Circuit Revision Change to the CoolRunner-II Family of CPLD Devices

PCN2004-24 (v1.2) August 19, 2005

Product/Process Change Notice - FYI

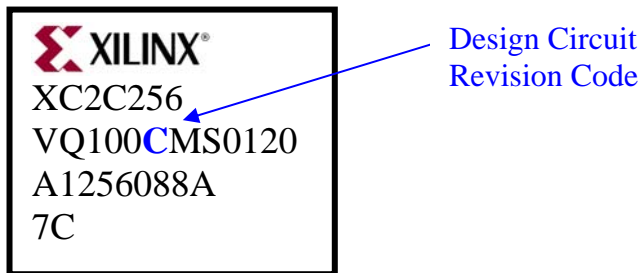
The design circuit revision code on the package topmark can be found as shown below:

The new XC2C128 and XC2C256 circuit revision codes are currently in production. Additional family members will be released to production per the table below. Customers should expect to receive devices of both circuit revisions until inventory of the earlier circuit revision is depleted. The new design circuit revision codes by family member are as follows:
